City of Alexandria, Virginia  
Waterfront Implementation

## Technical Memorandum 6 PUMP STATION CAPACITY AND SIZING

FINAL | February 2023

Figure 1 Southern Pump Station (PS1) Aboveground Layout

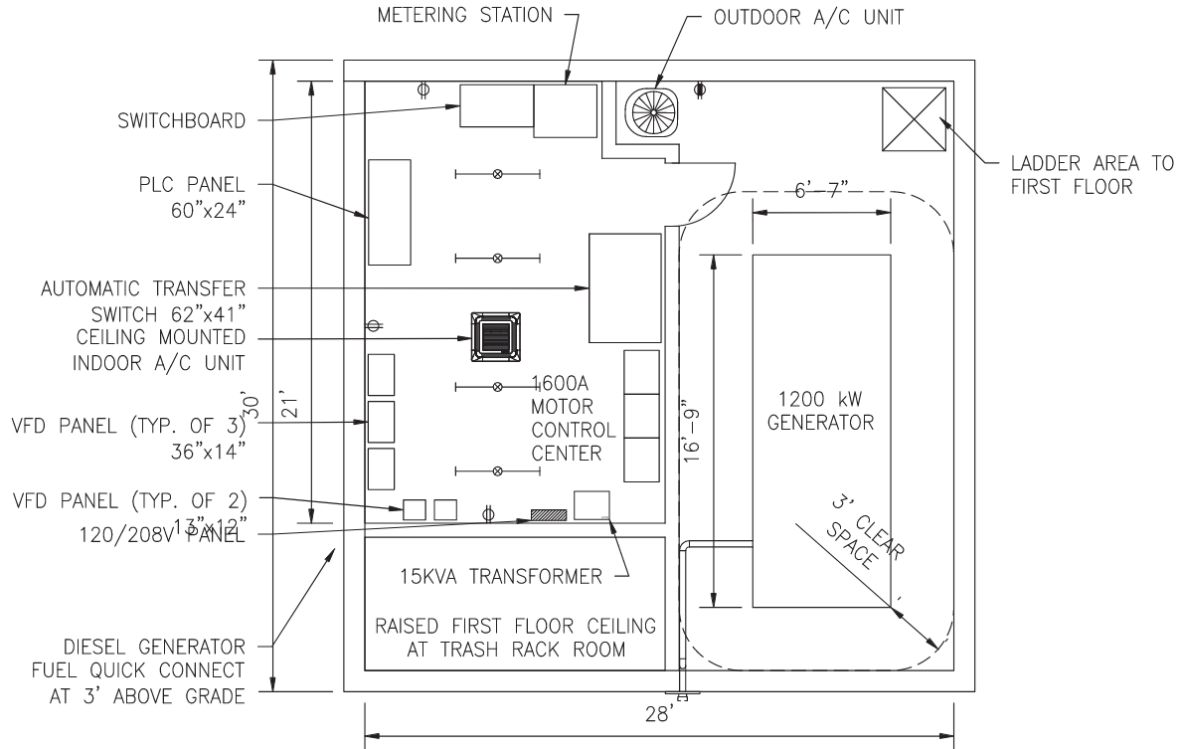
Given the proposed layout, it may be important to keep the following operational considerations in mind while proceeding in design:

- The current electrical room layout does not allocate space to a workstation for an operator. Slight configuration of the space could accommodate a corner design between the PLC panel and switchboard. This would require moving the outdoor A/C unit towards the ladder area, extending the wall length of the electrical, and shifting the switchboard and metering station.
- Only outside access to the pumps is permitted. An operator and/or maintenance crew will need to bring a portable crane.
- Upstream and downstream isolation of the screens is not shown. Isolation can be done via stop logs or gate operations. In either case, ingress and egress of staff must be considered. Stop logs will require on-site storage. Collectively the considerations could modify the building footprint, but not significantly.

Figure 7 Layout Showing Modifications to the Aboveground PS2 Footprint

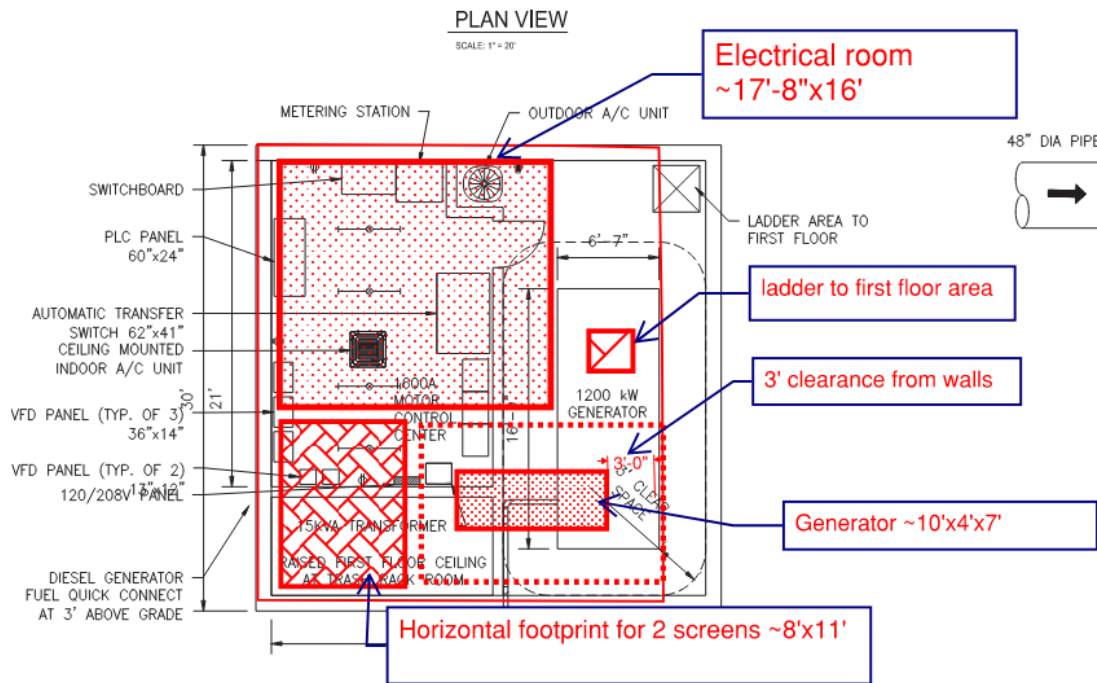
Figures 7 and 8 show two proposed layouts for the aboveground area of PS2; Figure 7 maintains the existing emergency generator and fuel tank location whereas Figure 8 assumes these components can be relocated to an alternative location. As shown in both figures, opportunities to resize and reconfigure the aboveground dimensions are a direct result of reduced electrical demand, including smaller electrical distribution equipment and smaller bar screens. The resized electrical room – 17'-8" x 16' – consists of the three VFDs assumed to be internal to the three-section motor control center (MCC) and a smaller automatic transfer switch (ATS) panel (in comparison to the baseline). In Figure 7, the space requirement of the emergency generator is less due to the capacity reduction from 1200 KW to 100 KW. The two bar screen screens sized for a peak flow of about 16 mgd into the wet well require a horizontal footprint up to 11-feet by 8-feet, which is the most conservative estimate. **Overall, the PS2 aboveground footprint may be reduced by approximately 15 percent in comparison to the baseline assuming the emergency generator and fuel tank remain at PS2.**

Figure 8 Layout Showing Modifications to Aboveground PS2 Footprint with Generator Relocated

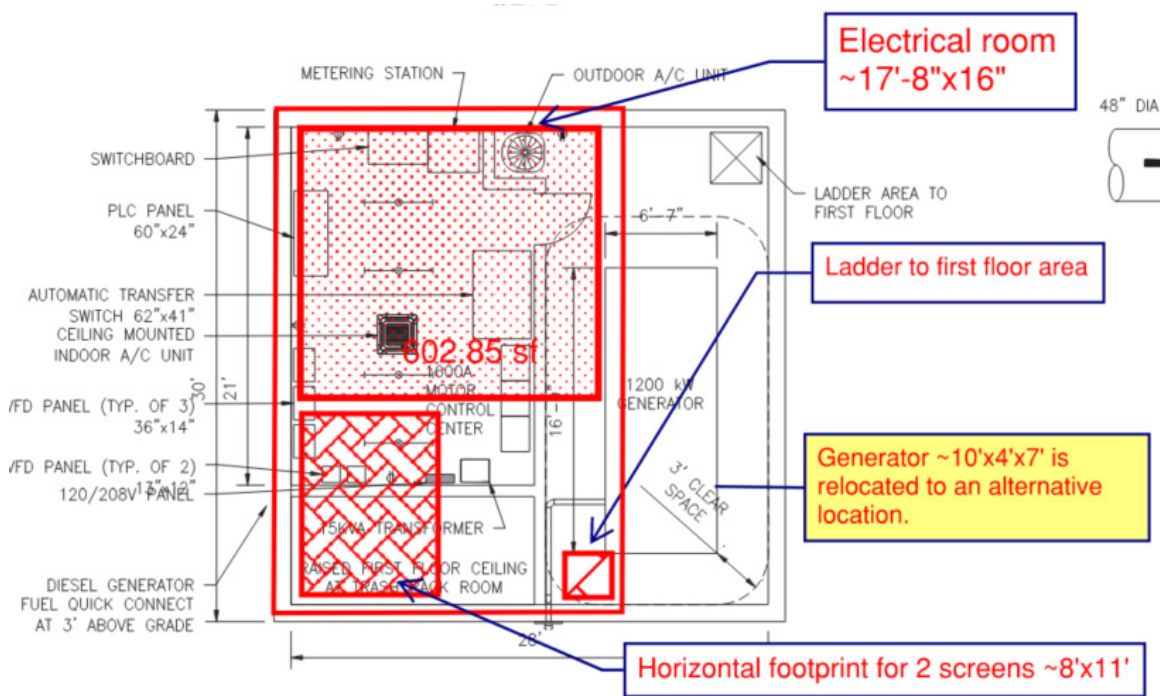
Figure 8 assumes the emergency generator is relocated offsite. Since the space below the generator was unoccupied, both the first and second floor of PS2 can be removed, and an access hatch shall be installed at grade to facilitate the removal of pumps from the wet well as needed. **If an appropriate location for the generator (and diesel fuel tank) can be identified and secured, then the aboveground footprint of PS2 can be reduced by one-third or 33 percent in comparison to the baseline.**

Figure 9 Layout Showing Modifications Made to the Belowground PS2 Footprint

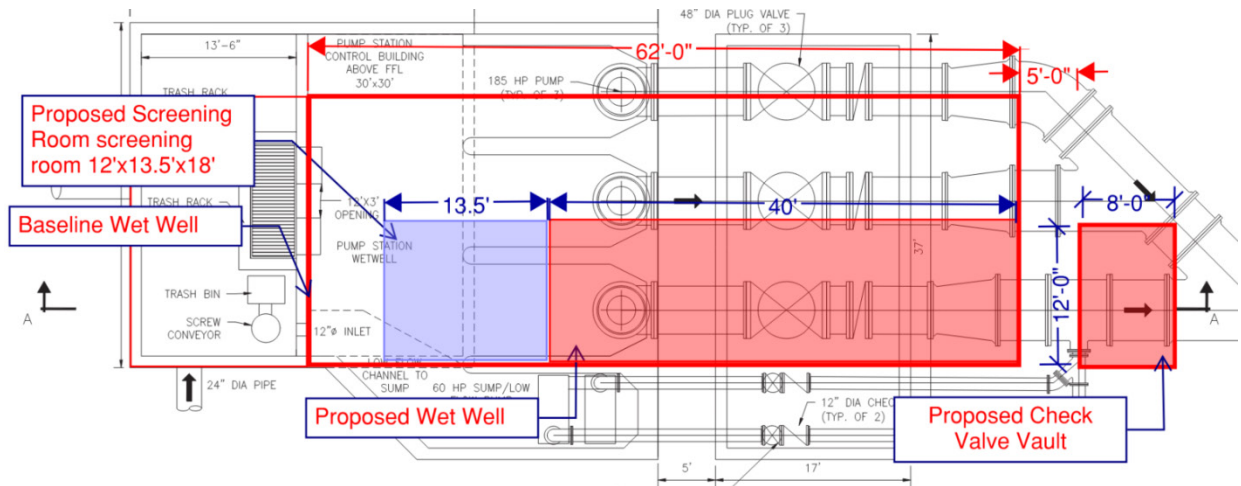
Figure 9 shows the proposed layout for the belowground area of PS2, including the revised dimensions of the wet well, check valve vault and screenings room. The width of the wet well can be reduced from 37-feet in the Baseline Project to 12-feet. This is because Carollo recommends three smaller, standard submersible pumps as opposed to the five submersible axial pumps in the Baseline Project. The decreased width of the wet well subsequently decreases the width of the room that houses the screens as well as the check valve vault. The diameter of the discharge pipes required for the low flow pumps is 12-inches and the outfall pipes can be reduced from 60-inches to 16-inches because of the lower discharge rate. Due to the reduced pipe sizes, the 13-foot (L) by 10-foot (W) energy dissipator can also be reduced to 6-foot (L) by 6-foot (W). **Overall, the underground footprint is reduced by 70 percent, and the modified layout offers greater siting flexibility in comparison to the baseline.**

Figure 10 Northern Pump Station (PS2) Layout within Existing Shoreline

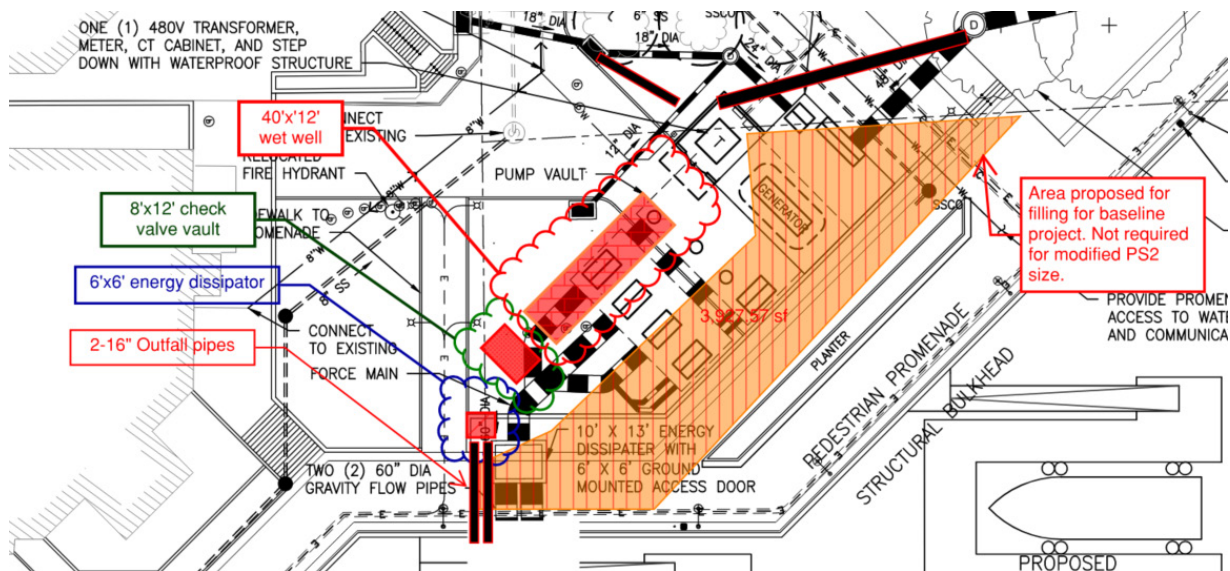
As shown in Figure 10, it is anticipated that the modified pump station footprint will allow for installation of the pump station and wet well within the existing filled area west of the bulkhead. This will eliminate the need for dredging and filling of a section of the river to accommodate the baseline pump station and limiting site disturbance during construction.
